PCI 9054

Design Notes Rev. 1.8
July 2003

Design Notes Documentation

Sample VPD Implementation Circuit

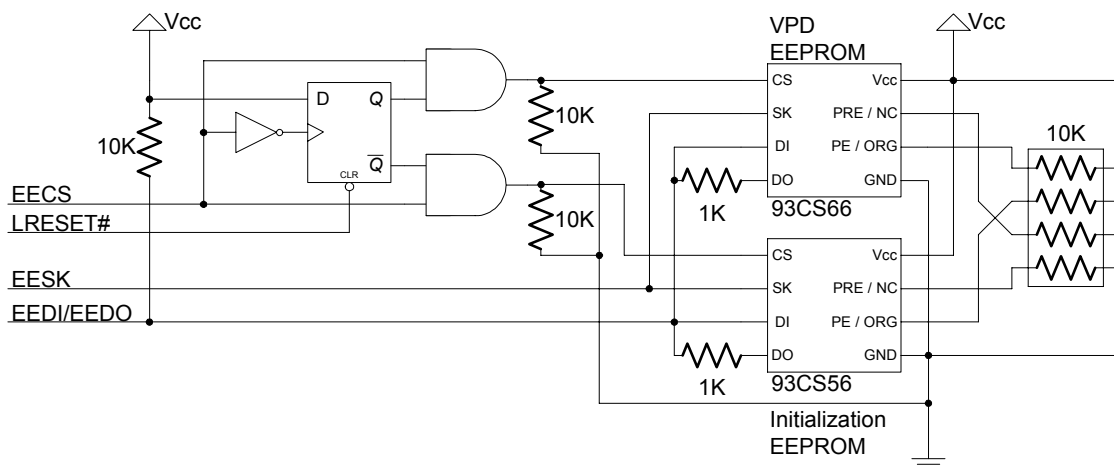
Solution/Workaround: VPD data storage can be implemented with a serial EEPROM used exclusively for VPD (and not containing PCI 9054 configuration data). Because the PCI 9054 will attempt to read configuration data through the serial EEPROM interface at power-up reset, the VPD EEPROM should not be enabled until PCI 9054 initialization completes (when EECS de-asserts).

The following sample circuit includes two serial EEPROMs, one for initialization and the other for VPD, with only one EEPROM enabled at any time. The circuit initially enables the Initialization EEPROM during power-up reset. After the first EECS de-assertion, the circuit enables access to the VPD EEPROM and disables access to the Initialization EEPROM. The D flip-flop and inverter can both be replaced by a negative edge-triggered J-K flip-flop such as the 74HCT107, with its J input tied high and its K input tied low.

To allow programming of the Initialization EEPROM, the circuit can be modified such that the flip-flop CLR input is driven by the output of an AND gate instead of from LRESET# directly, with LRESET# connected to one of the AND gate inputs. If any AND gate input is low, the gate output is low, which will enable the Initialization EEPROM and disable the VPD EEPROM.

Sample VPD implementation circuit without initialization EEPROM, and Local CPU sets PCI 9054 Init Done bit

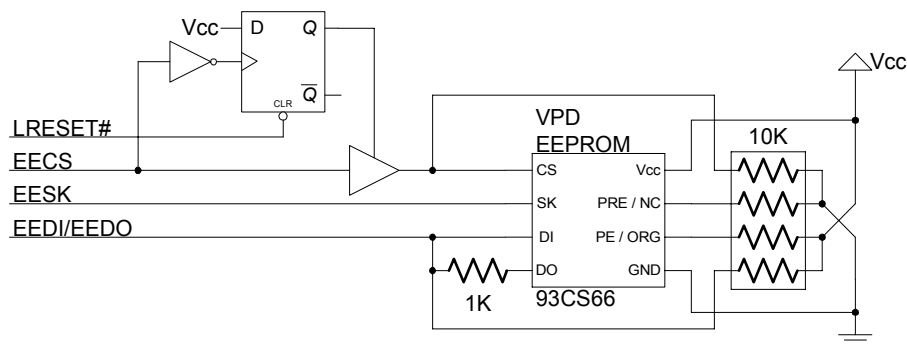
The following sample circuit includes one serial EEPROM for VPD-only access, and applies to designs having a Local Bus processor that will initialize the PCI 9054, including setting of the Init Done bit (LMISC[2] = 1).

If neither a serial initialization EEPROM nor Local CPU is present to set the Init Done bit, the EEDI/EEDO line must be pulled low with a 1K resistor (which will cause the PCI 9054 itself to set the Init Done bit). To implement VPD in such case, the EEDI/EEDO line in the above circuit would have to be switched to connect only to a pull-down (removing connection to the EEPROM) during the time that the Q output of the D flip-flop is low.
